Service Campaign Bulletin

Campaign No. 2013010003, January 2013

SUBJECT: **Model 204, Model Year 2012**
Apply Seam Seal to the Left and Right Rocker Panels

**Figure 1**

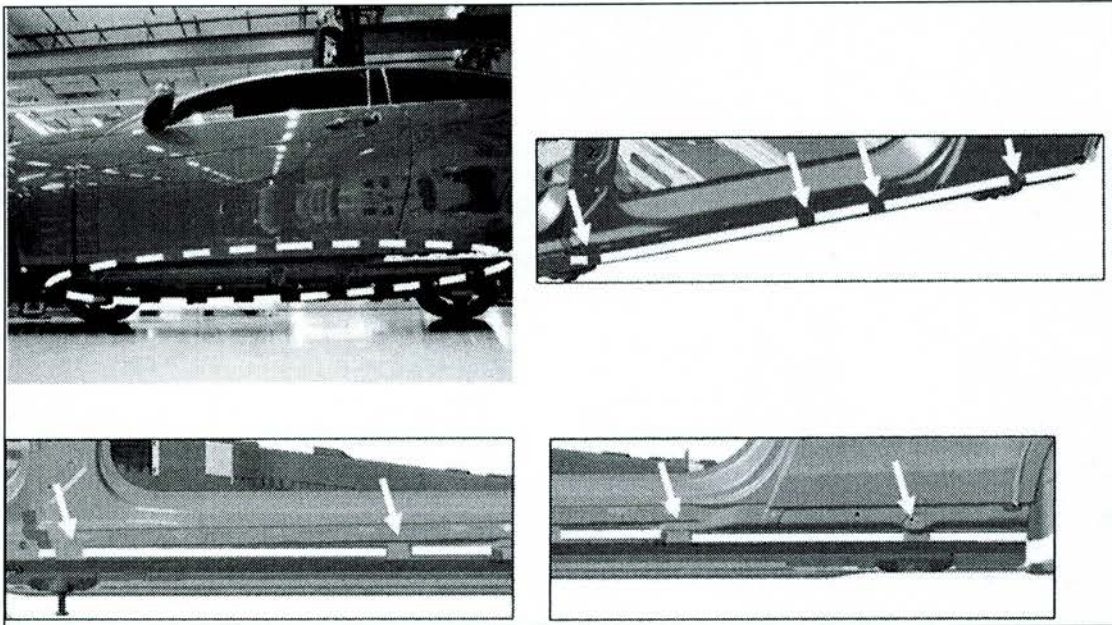
This Service Campaign has been initiated because Daimler AG (DAG), the manufacturer of Mercedes-Benz vehicles, has determined that the seam seal at the rocker panels may be missing due to a production issue. An authorized Mercedes-Benz dealer will apply seam seal on the left and right rocker panels at the next workshop service.

1. Remove/install longitudinal member panel (circled, Figure 1) at left and right, refer to WIS: AR88.80-P-6000CW.

2. Clean the area to be processed under the longitudinal member panel thoroughly and then degrease with silicone remover (marked area).

3. Apply missing sealant (to marked areas, Figure 1) using a standard size caulking gun (locally sourced).

Ensure that the water drains (4 on each side) remain open (arrows, Figure 1).
